BRIEF DESCRIPTION OF REQUEST
 Final sign-off on EPC amended site plan for La Mirada Shopping Center/Wymont Place subdivision.

**RE: The Wymont
4315 Wyoming Blvd NE
Conceptual Grading and Drainage Plans
Engineer's Stamp Date: No Date
Hydrology File: G19D004**

Project #2019-002309
SI-2021-00370—Site Improvement, Major Amendment to
Site Plan

Re: La Mirada/Wymont Place (PR-2019-002309, SI-2021-00370) Final Site Plan Sign-off

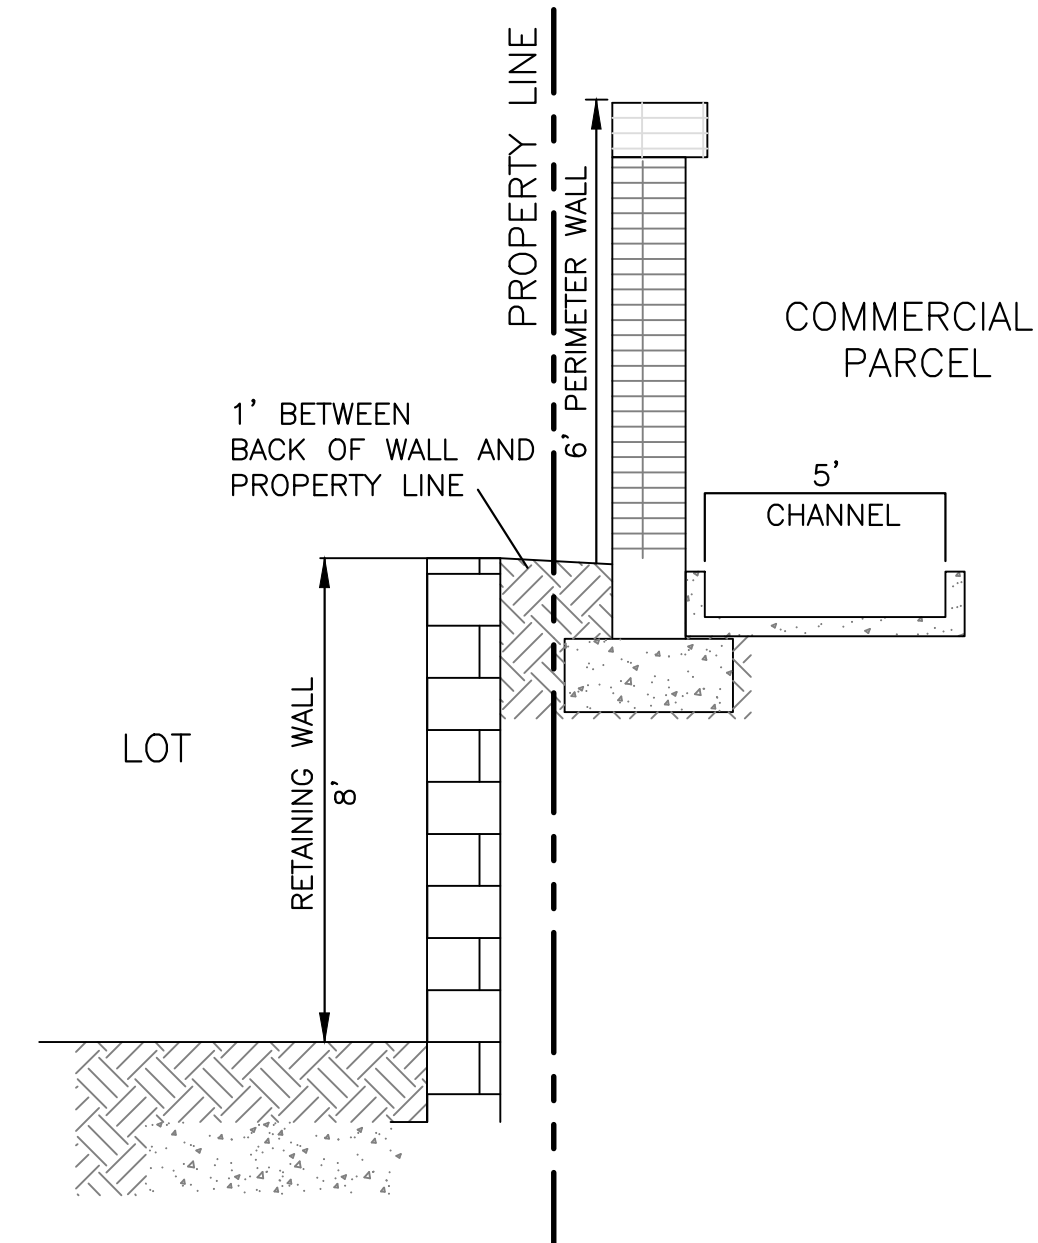
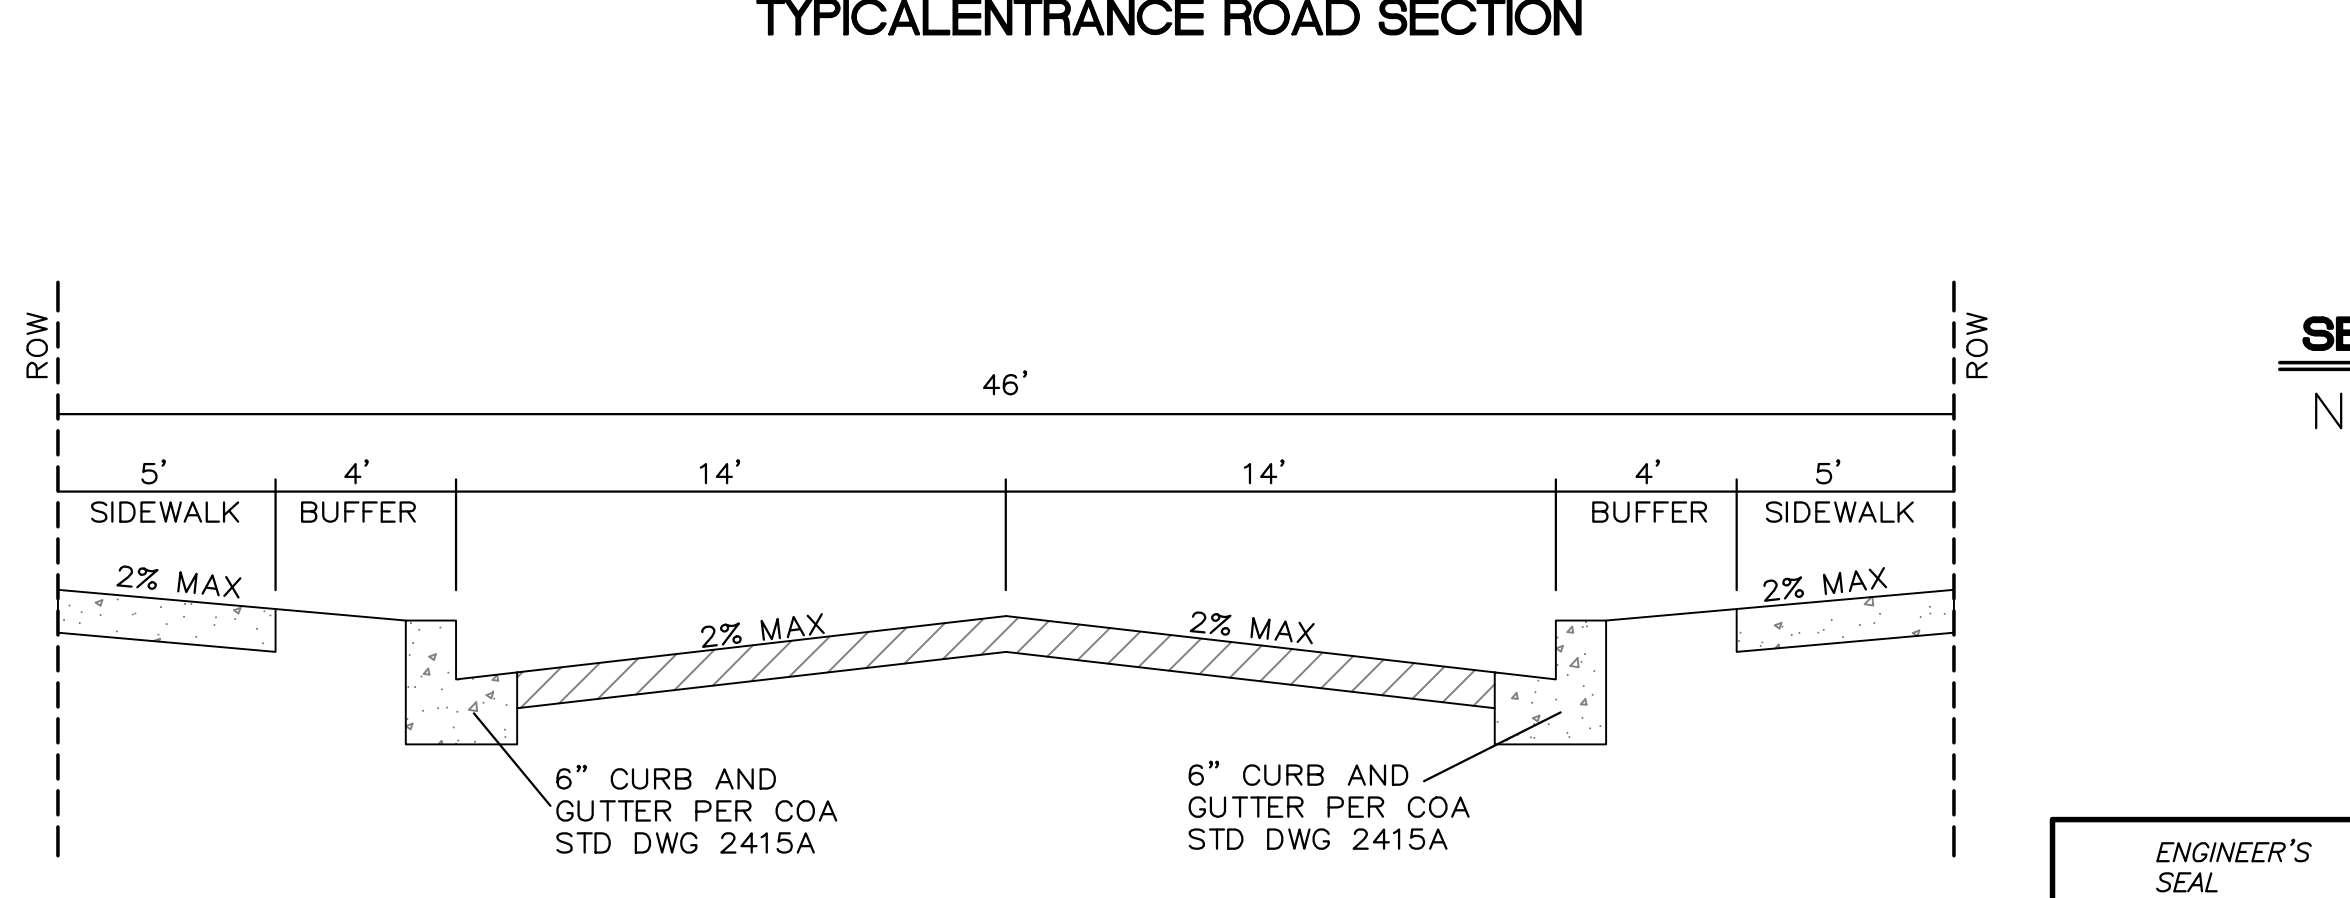
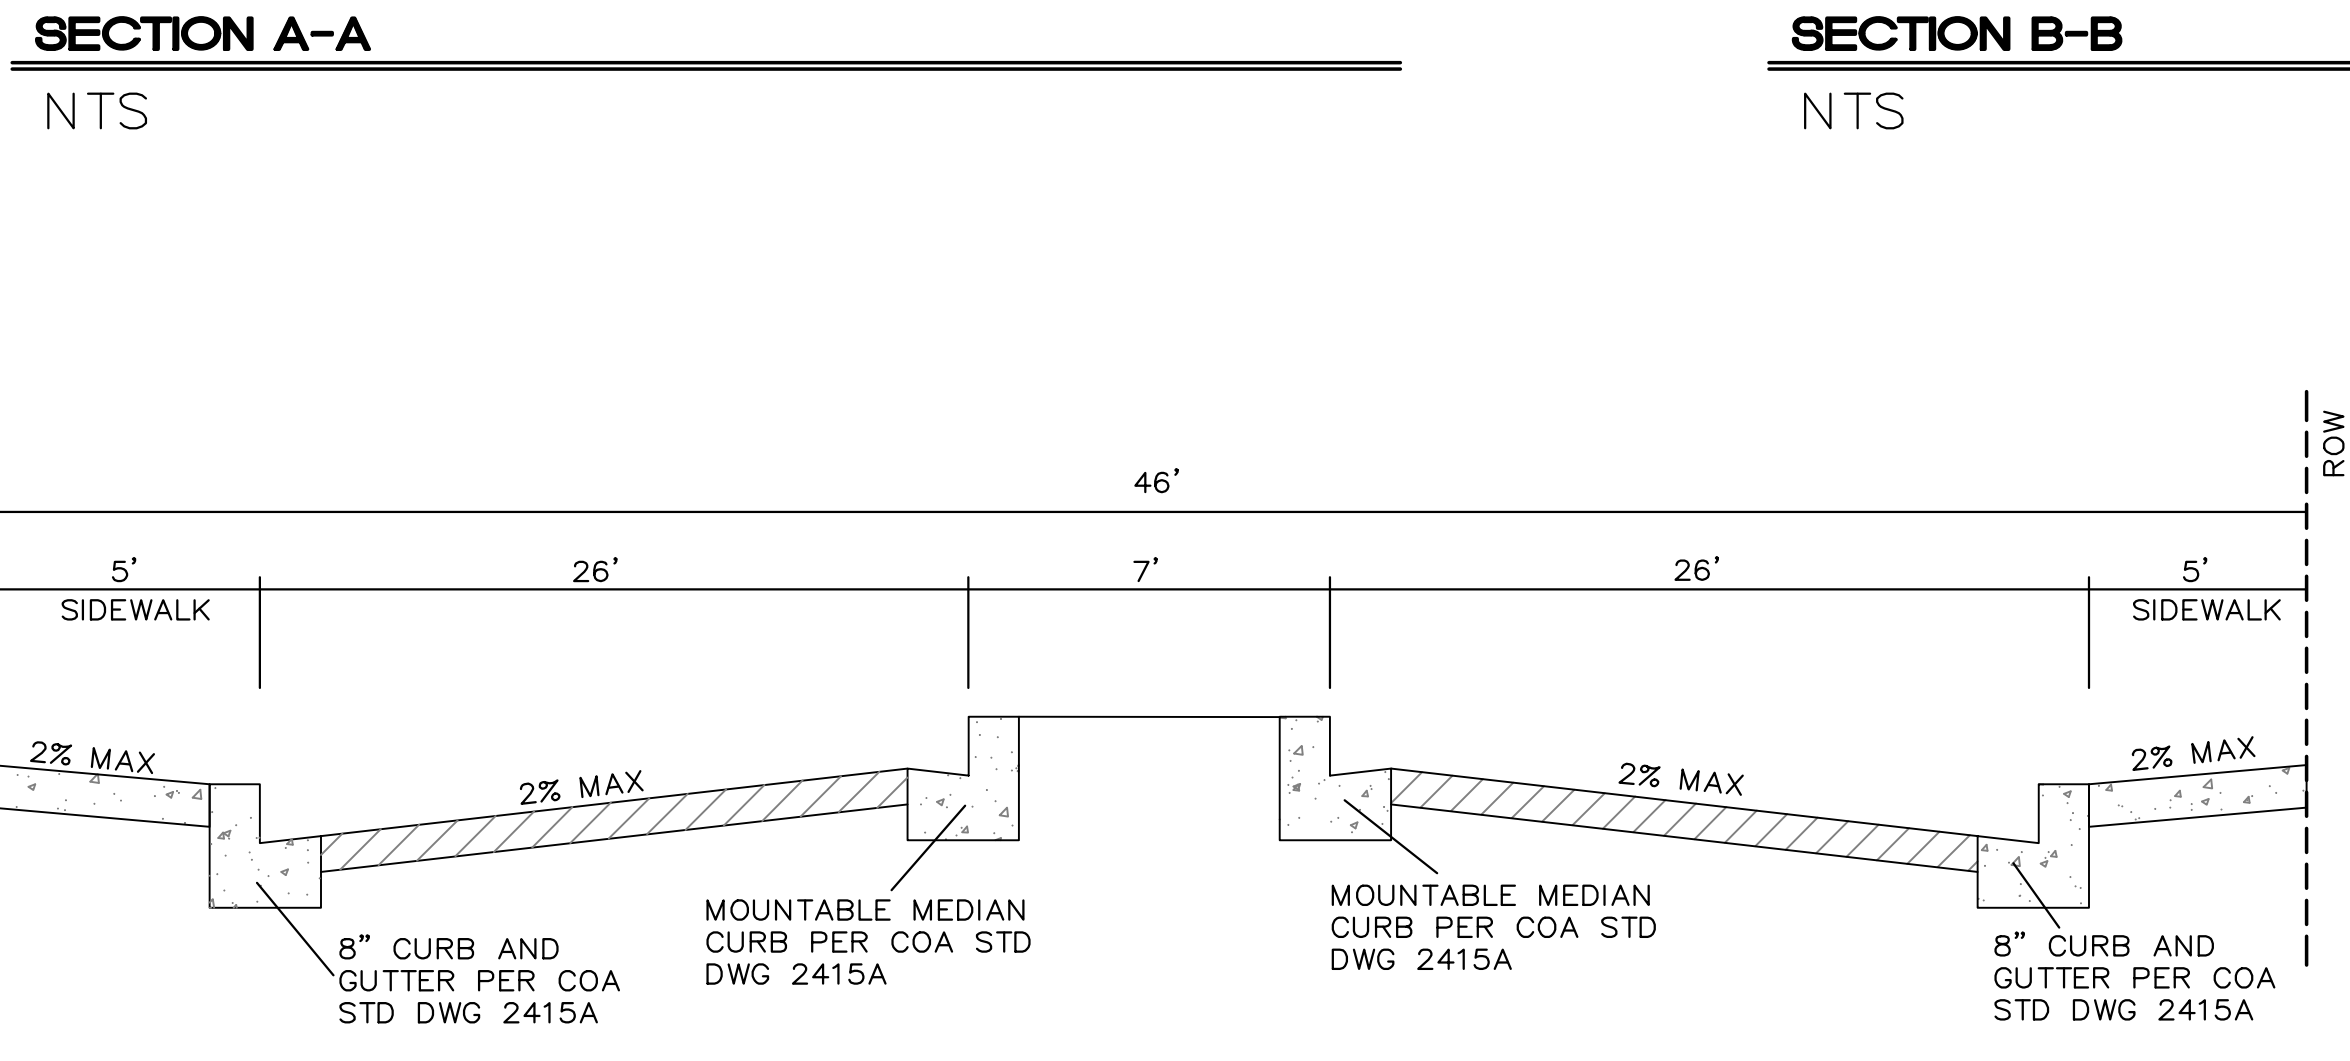
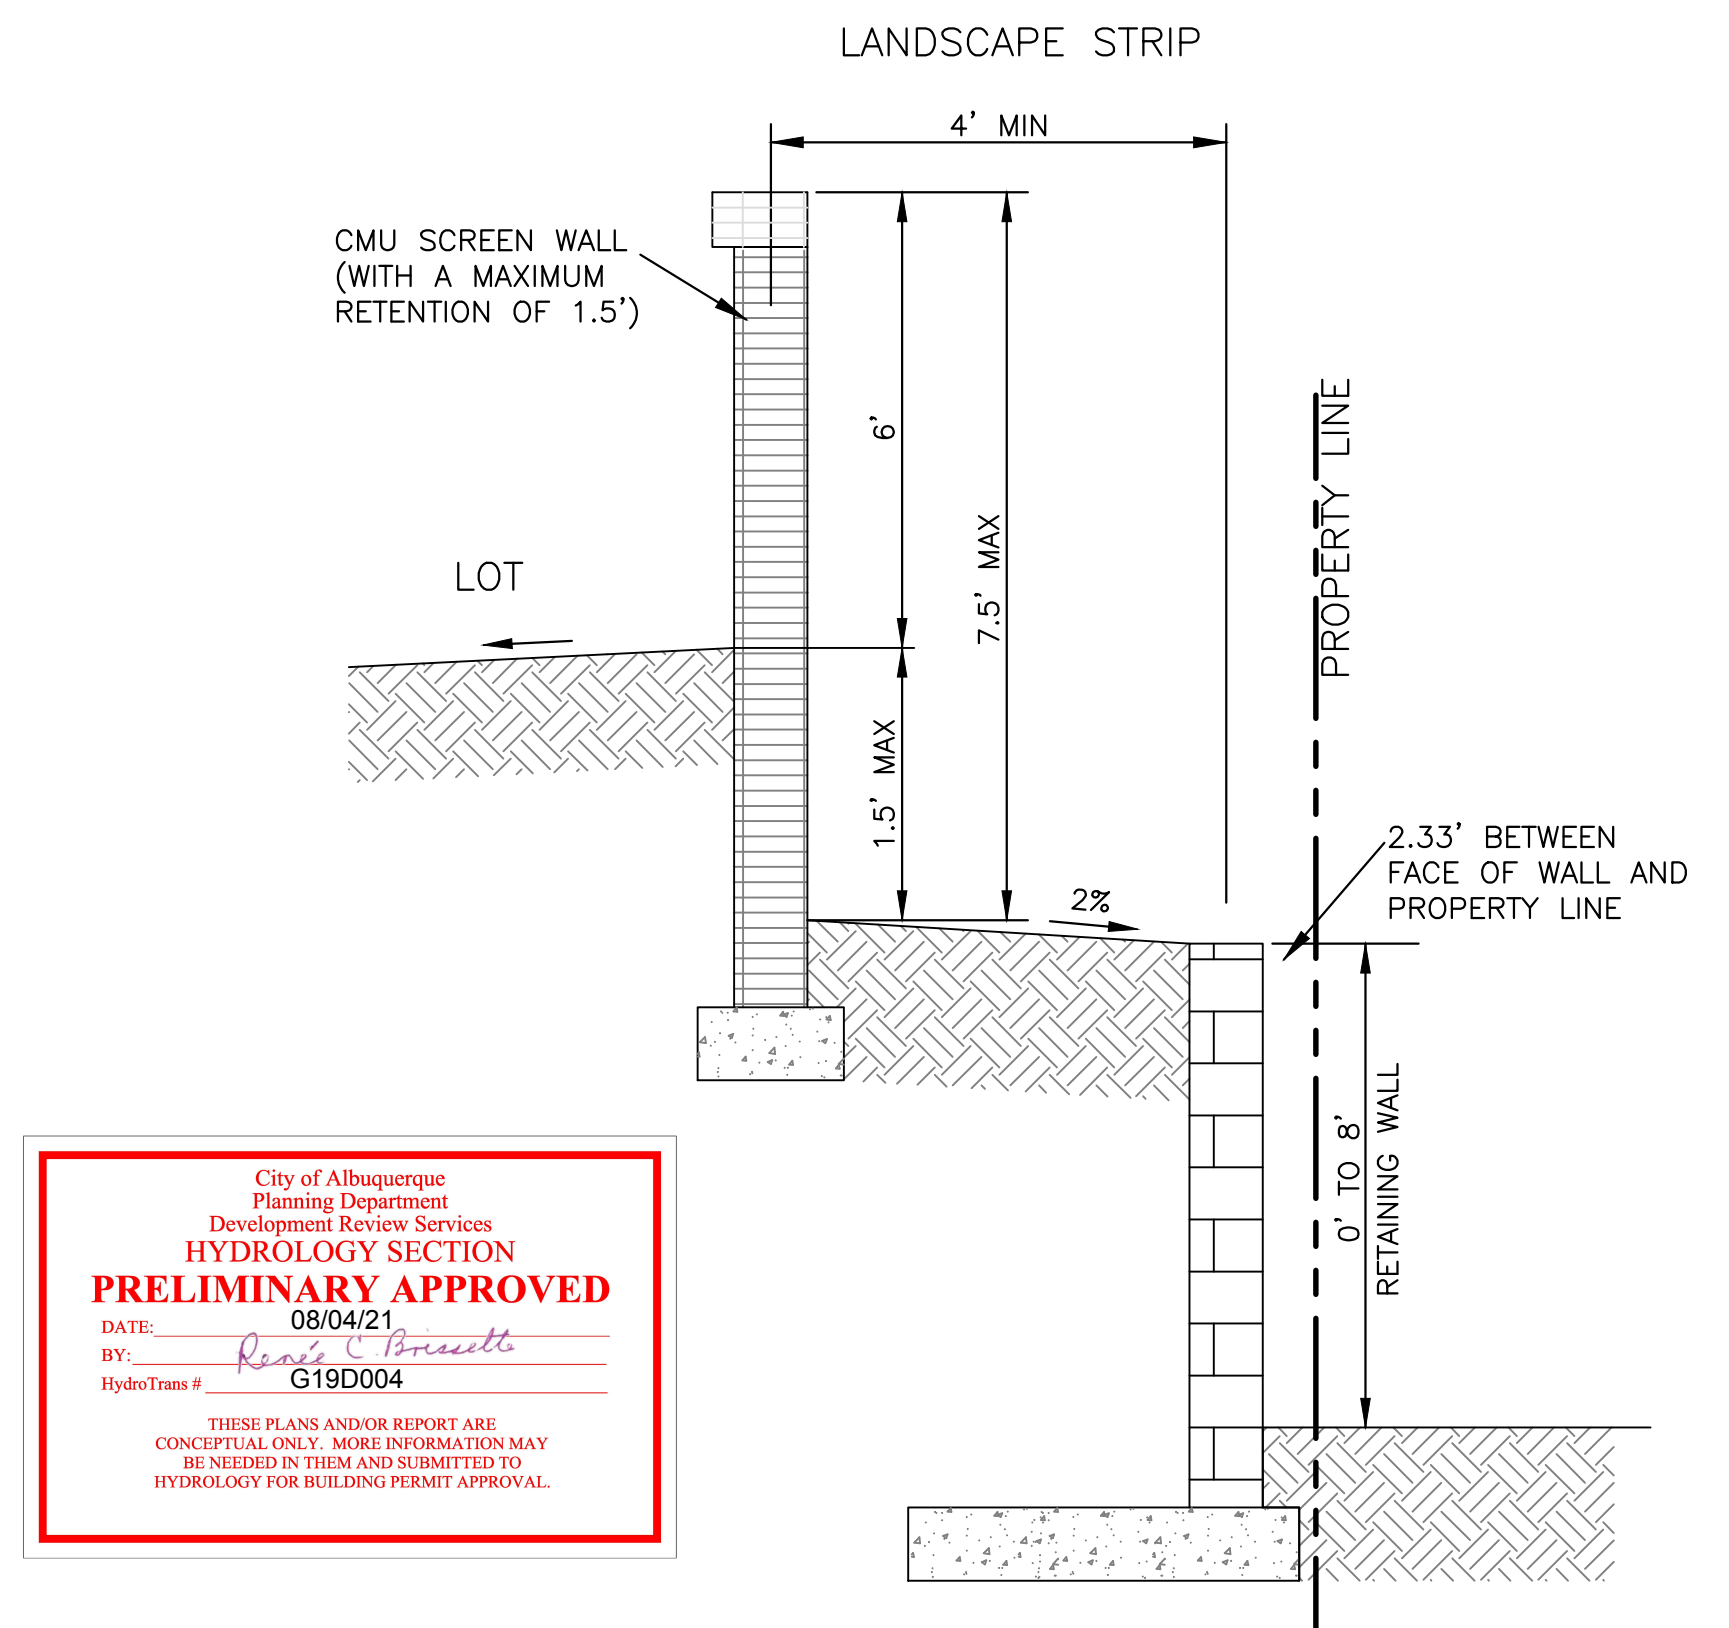
7. Walls:
Pursuant to IDO table 5-7-1 Maximum Wall Height, maximum wall height in Mixed Use zone districts is 8 feet. Currently, wall sections show terraced walls with a range of up to 12 feet in height. Any wall that is proposed to be higher than 8 feet will need additional approval from the City Engineer, pursuant to IDO Subsection 14-16-5-7(F)(1)(a).

The terraced walls have been updated to comply with this requirement as shown on Sheet GR-2.
